UNITED STATES PATENT AND TRADEMARK OFFICE

APPLICATION NO.	FILING DATE	FIRST NAMED INVENTOR	ATTORNEY DOCKET NO.	CONFIRMATION NO.
09/511,267	02/23/2000	Joachim Eicher	0652.2020002/LEA/ALF	3620

Office Action Summary	Application No.	Applicant(s)
	09/511,267	EICHER ET AL.
Examiner	Art Unit	
Teena K Mitchell	3761

DETAILED ACTION

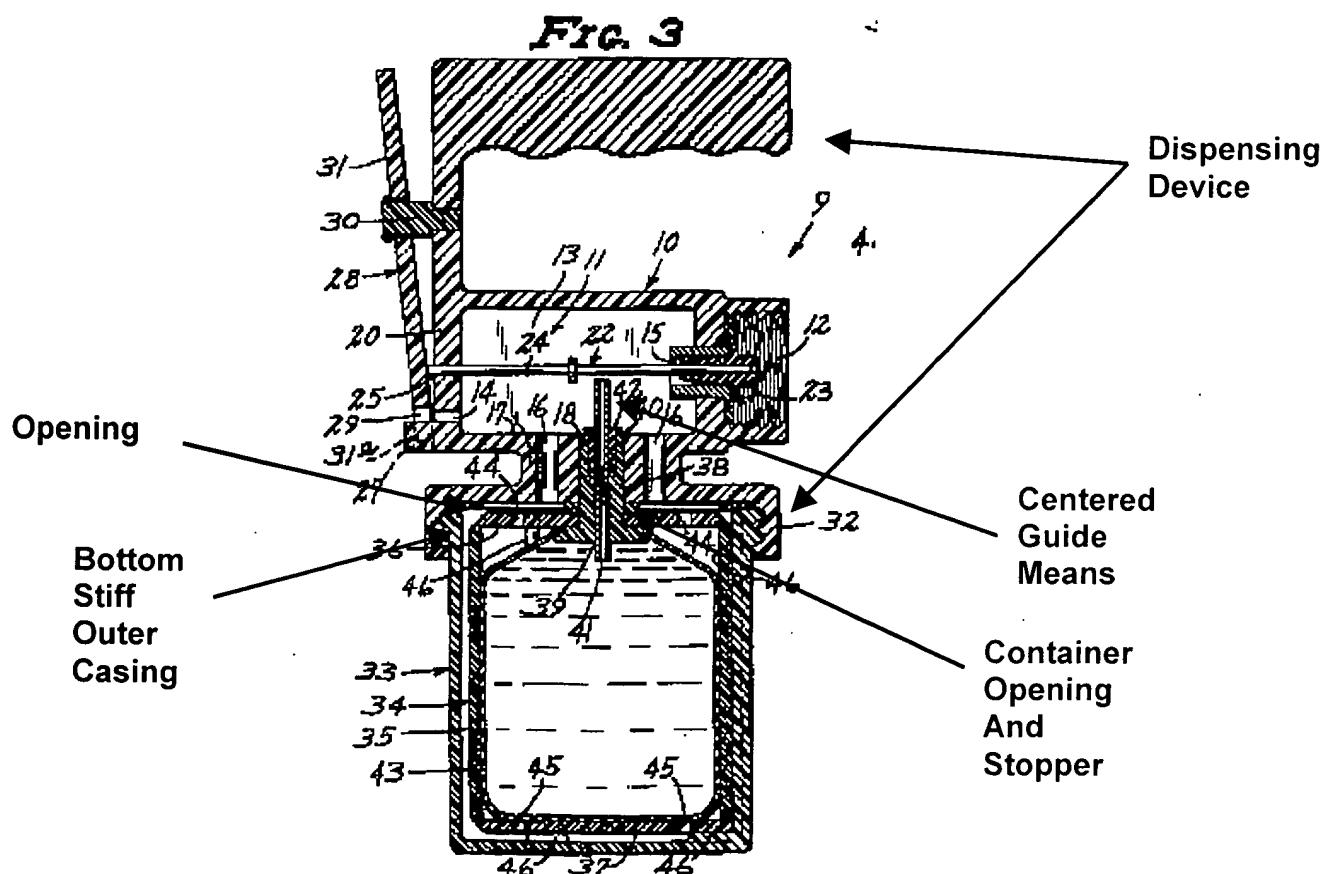
Hultgren (as best understood by the examiner) in a cartridge for a liquid (9) discloses, which can be connected to a dispensing device (see illustration of Fig. 3 below), the dispensing device including an upper portion (at 38) for receiving the cartridge (9) and a lower portion (32) which can be pushed over a connected cartridge, the upper portion of the device being provided with a connection portion (38) and with a dispensing connection portion (10) for drawing off the liquid, the cartridge comprising:

- a stiff outer casing (33);
- a container (34) which is stable in respect of shape and which is disposed in the casing (33);
- a collapsible bag (43) disposed in the container (34) and containing the liquid (Fig. 3);
- wherein the stiff outer casing (33) includes a bottom (See illustration of Fig. 3 below) provided with an opening, and

- wherein the container includes an opening and a stopper (See Fig. 3 illustrated below), the stopper including an insertion connection portion (see Fig. 3 illustrated below) which forms a sealingly closing, centered guide means for the dispensing connection portion, and
- wherein the stopper is non-releasably connected by the outer casing to the container (Fig. 3), and
- wherein the cartridge is releasably connected to the connection portion on the upper portion of the dispensing device (Fig. 3).
